CITY PLAN COMMISSION**THURSDAY, JANUARY 23, 2025****FILE NUMBER:** S245-060**SENIOR PLANNER:** Hema Sharma**LOCATION:** Spruce Valley Lane, south of Pentagon Parkway**DATE FILED:** December 26, 2024**ZONING:** R-7.5(A)**CITY COUNCIL DISTRICT:** 3**SIZE OF REQUEST:** 0.894-acres**APPLICANT/OWNER:** Richard Stauffer, City of Dallas

REQUEST: An application to create one 0.894-acre lot from a tract of land in City Block 6979 and to dedicate right-of-way on property located on Spruce Valley Lane, south of Pentagon Parkway.

PRELIMINARY PLAT

PECAN GROVE PARK
 LOT 1, BLOCK 6979
 ABRAHAM BAST SURVEY, ABSTRACT NO. 109
 CITY OF DALLAS, DALLAS COUNTY, TEXAS
 CITY PLAN FILE NO. S245-060
 DECEMBER 26, 2024

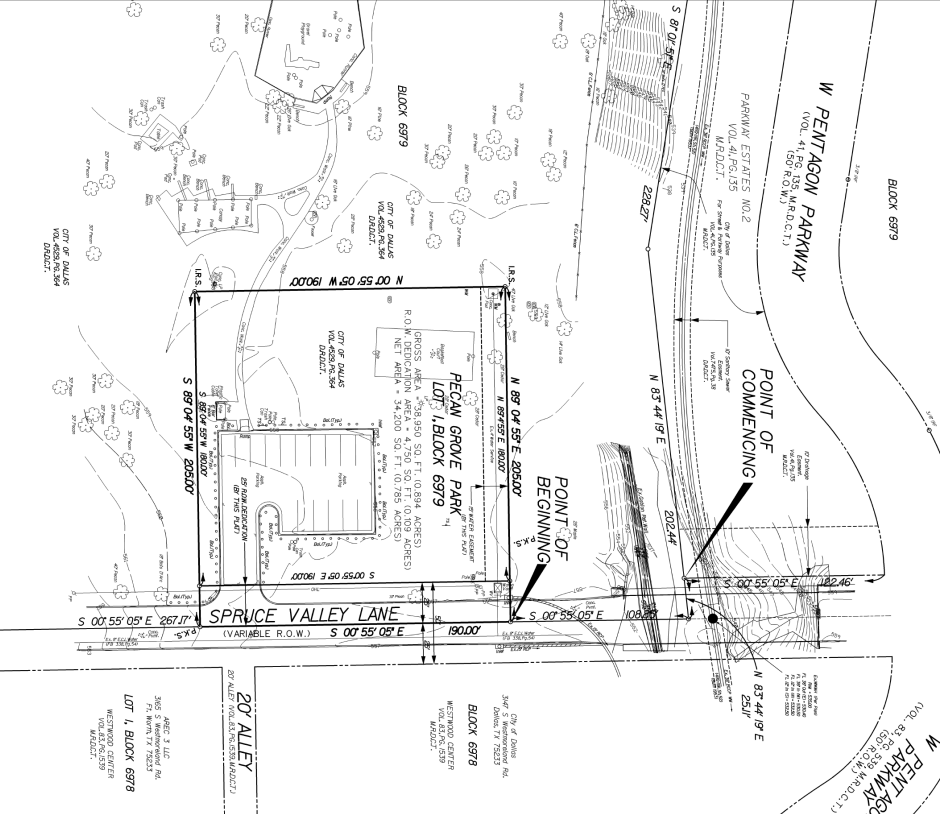
15. On the final plat, dedicate 28 feet of right-of-way (via fee simple or street easement) from the established centerline of Spruce Valley Lane. *Sections 51A-8.602(c), 51A-8.604(c) and 51A-8.611(c).*

31. On the final plat, change “W. Pentagon Parkway” to “Pentagon Parkway”. Section 51A-8.403(a)(1)(A)(xii).
32. On the final plat, identify the property as Lot 1 in City Block 1/6979.
